SITE PLAN REVIEW

Project Name: Stop N Save w/ car wash

FILE #SPR-95-57

TITLE HEADING: Site Plan Review - Stop 'N' Save
with a Car Wash

SHEET
 11

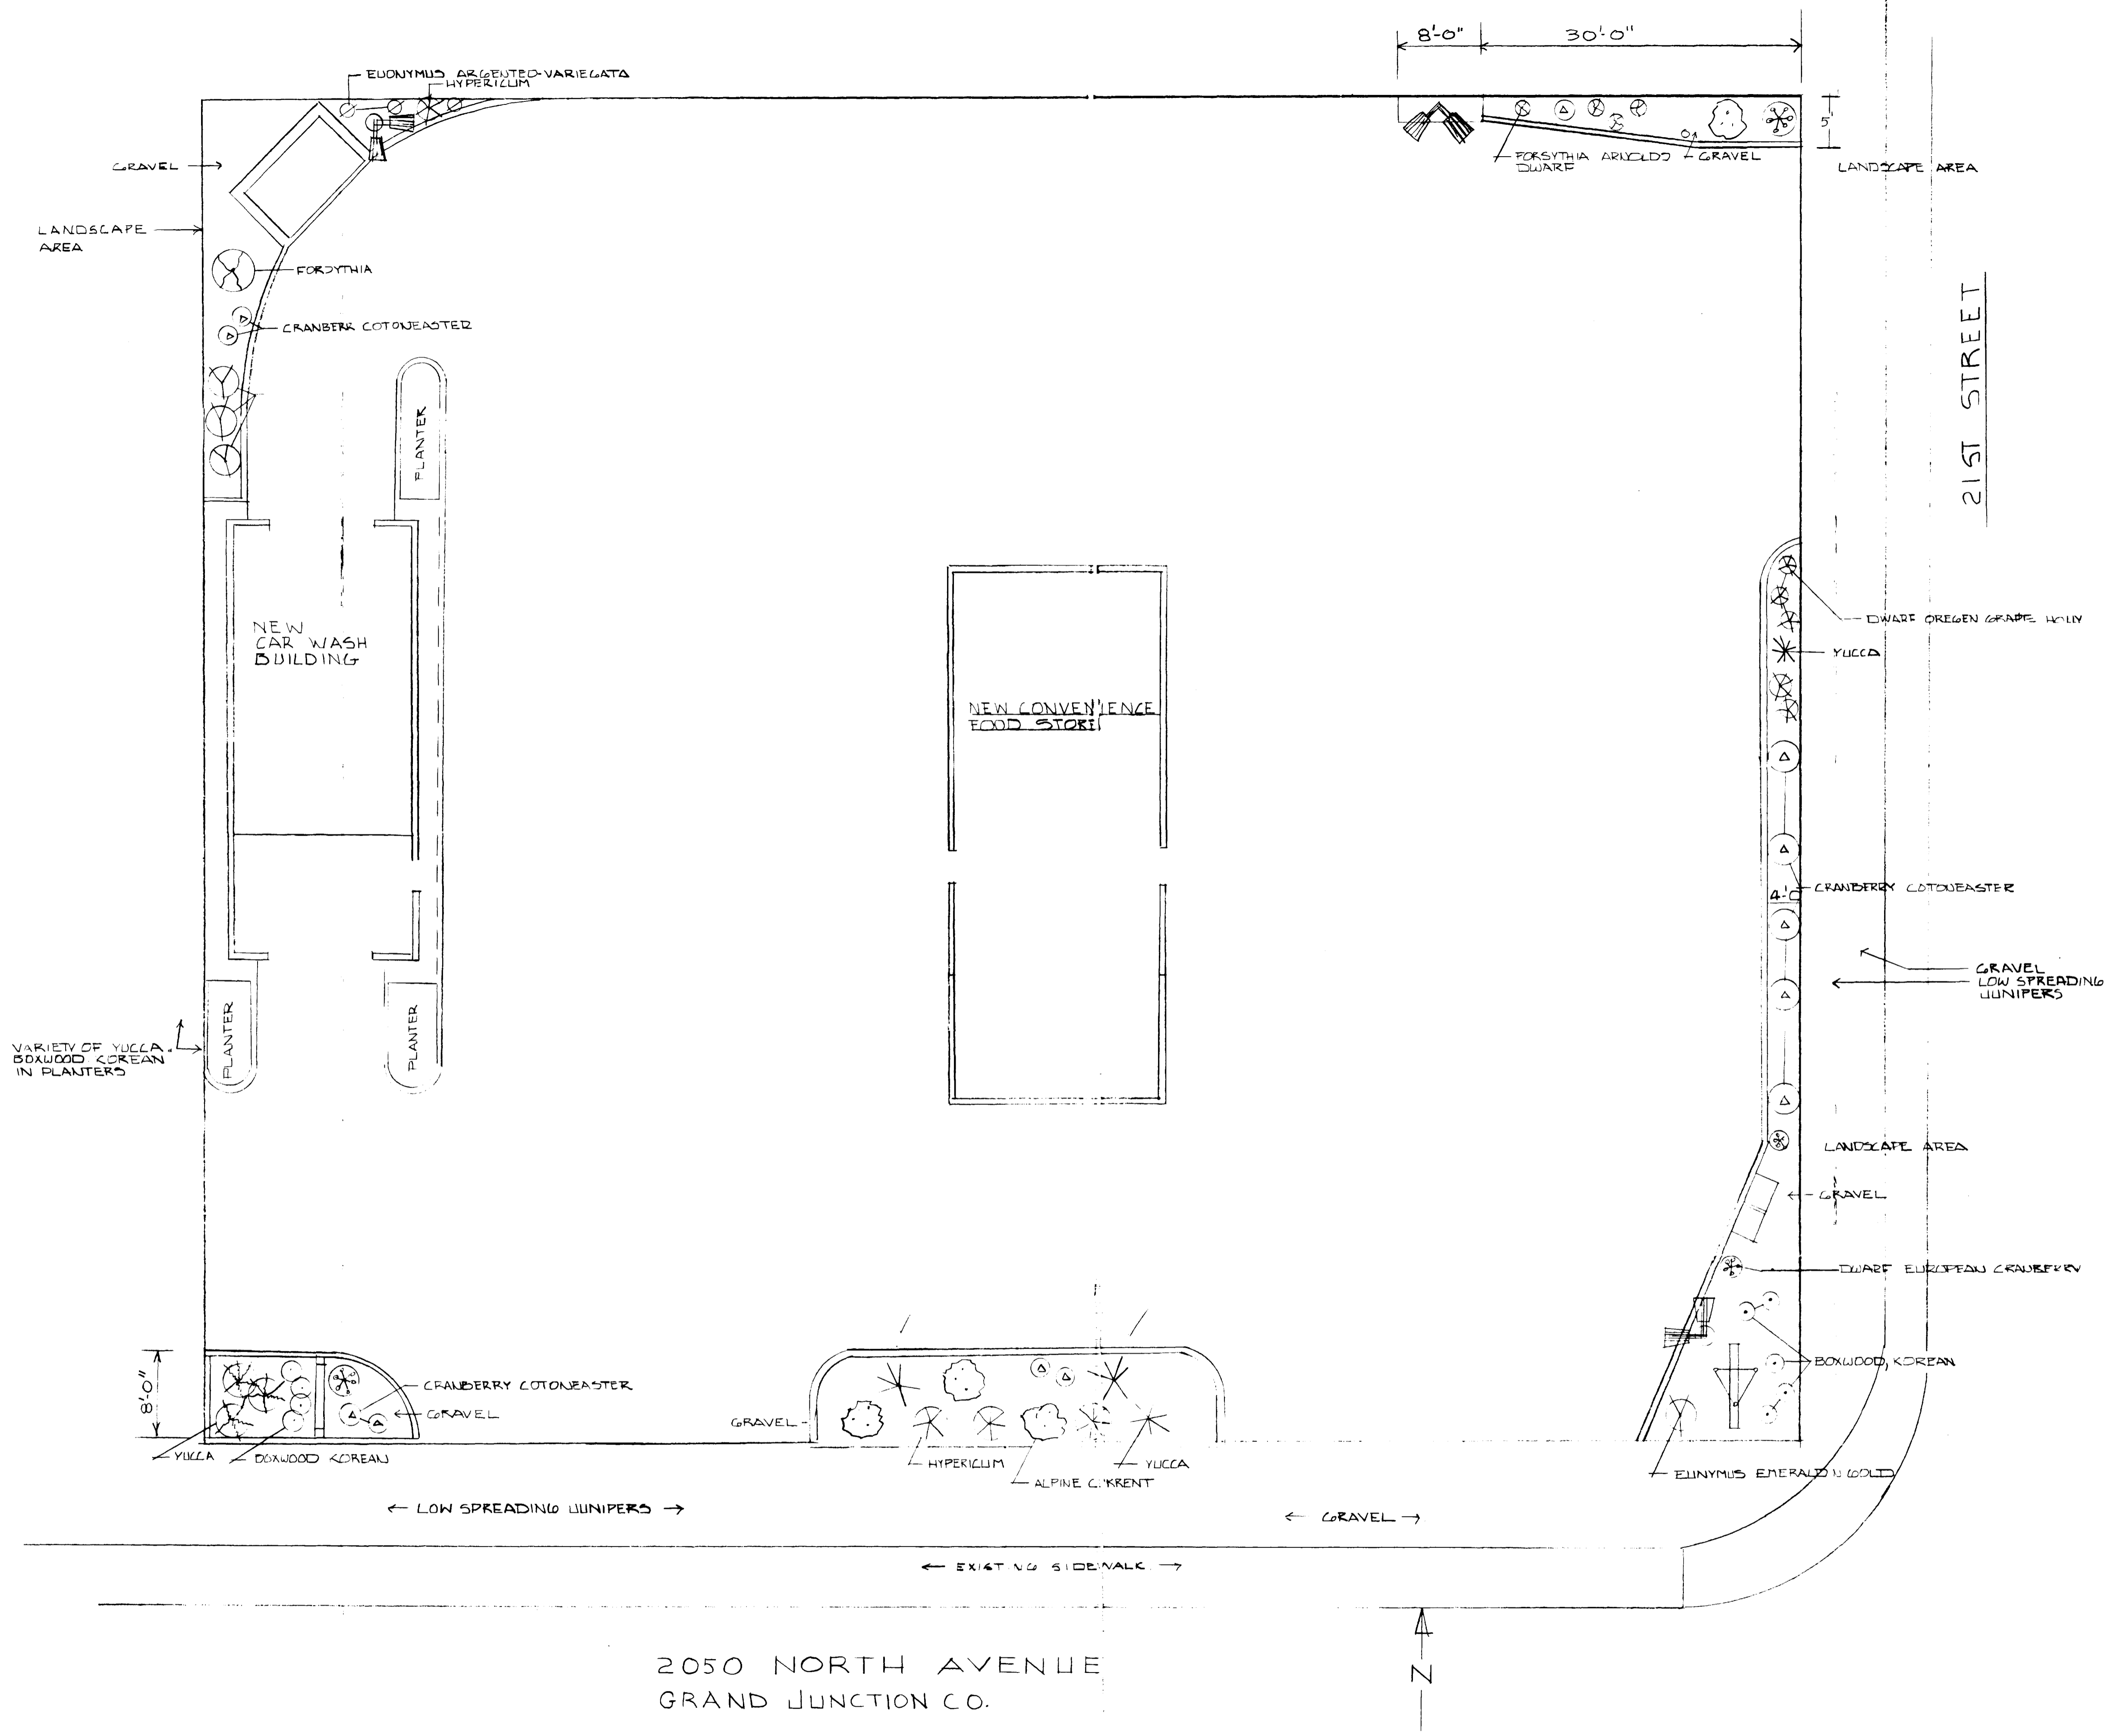
Based on the submitted landscape plan, additional landscaping will be required along North Avenue whereas the 21st Street frontage appears to meet the landscaping requirement. A complete review of the plan by the Community Development Department will occur when a complete Landscape Plan is submitted.

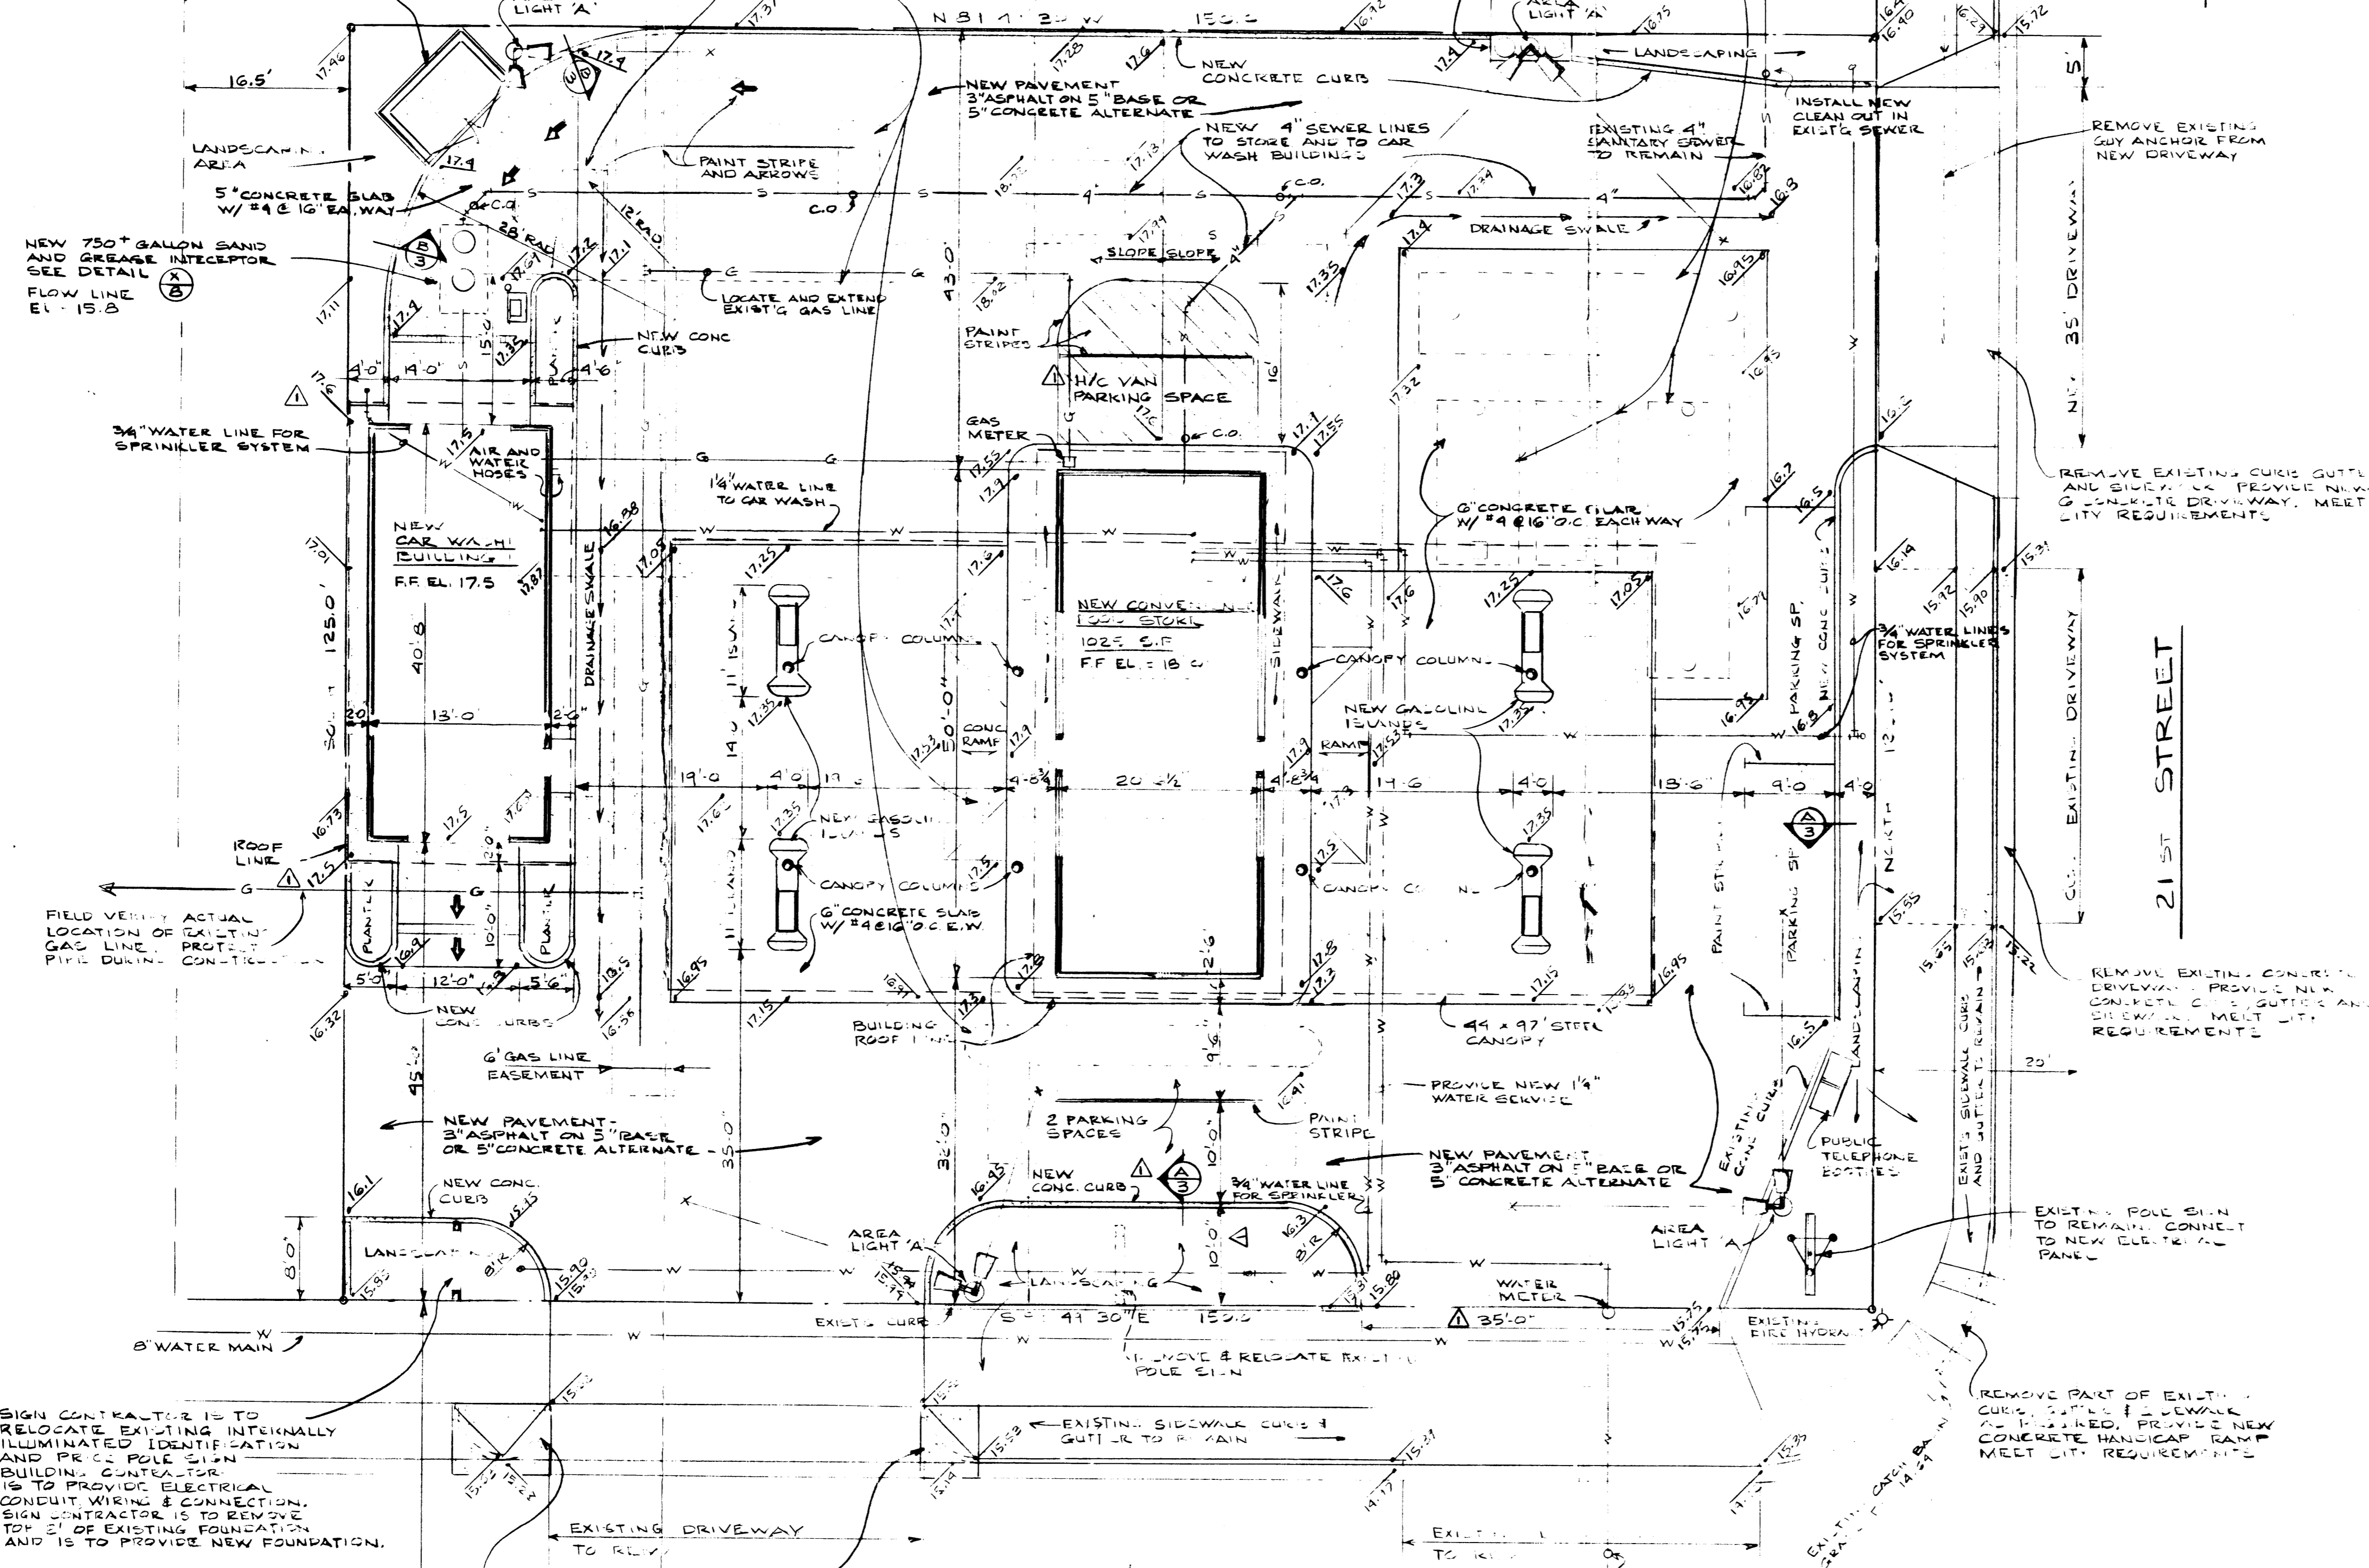
1. No drainage fee - no increase in site run-off.
2. Permit from City Engineering required prior to sidewalk construction.
3. The radii and curb on the westernmost driveway need to be removed and reconstructed to City Standards to meet accessibility requirements.
4. Please provide information on the number of current gas pumps, the number of proposed gas pumps so I can calculate the Transportation Capacity Payment. Credit for sidewalk, handicap ramp and driveway improvements will be given toward the Transportation Capacity Payment.
5. Is there a cross-access easement in place to use Wendy's driveway.
6. A barrier curb is needed along the west edge of the car wash to contain run-off and keep parked cars from hitting the building.

I would recommend that the trash dumpster area be of a transparent design (chain link or mock wrought iron), instead of 8' walls. Is there an elevation of the building? If so, could I take a look at it prior to final comments going back to the petitioner?

The Plan depicts access onto the adjoining parcel to the West without benefit of an easement. Is an easement provided? If not, access to the West must be restricted unless and until provided.

1. City submittal standards require drawings to be stamped and sealed by the preparing professional. In this case, the Site Plan must be stamped and sealed by the architect and the Grading and Drainage Plan must be stamped and sealed by an Engineer.
2. Landscape Plan incomplete for review - see attached checklist for deficient items.
3. Regarding landscaping, Section 4-2-13D of the Zoning and Development Code (copy attached) requires a minimum of seventy-five (75%) of the required front yard setback, or first five feet (whichever is greater) to be landscaped. The required landscaping for each frontage is calculated as follows:

4. City Code requires that the area within the City right-of-way (not covered by sidewalk, driveways, etc) be landscaped.
5. The parking provided on the south side of the convenience store does not permit vehicular access across the south side of the store and/or between the gas pumps. Suggest relocation of at least one space to the rear of the store. Spaces at the rear of the store should be reoriented perpendicular to the building since adequate maneuvering space exists. Minimum parking required is five (5) spaces.

In response to your staff comments dated March 27, 1995, a site plan is attached, revised April 6, 1995, addressing the following items:

Item 3. We have increased the size of the front center landscaping area as requested.

Item 4. The area in the right-of-way was shown on the site plan to be landscaped.

Item 5. There is no intent for the area south of the store to be used for traffic circulation. This area is necessary for the required parking. The handicap parking space is relocated to the north side of the store to allow for the required additional landscaping. Five parking spaces were provided as required (2 south of store, 1 north of store and 2 along the 21st street side). We do not feel that reorienting the north parking would be appropriate due to potential conflicts with cars in line for the car wash.

Item 3. The driveway radius is to be removed and ramp type approaches are to be constructed.

Item 6. Barrier curb is provided by the raised concrete apron along the west side of the car wash building as shown on the car wash building details. Finish grade elevations were added to further define this. There will be no significant runoff since the roof overhang covers this concrete apron and the roof slopes to drain to the east side.
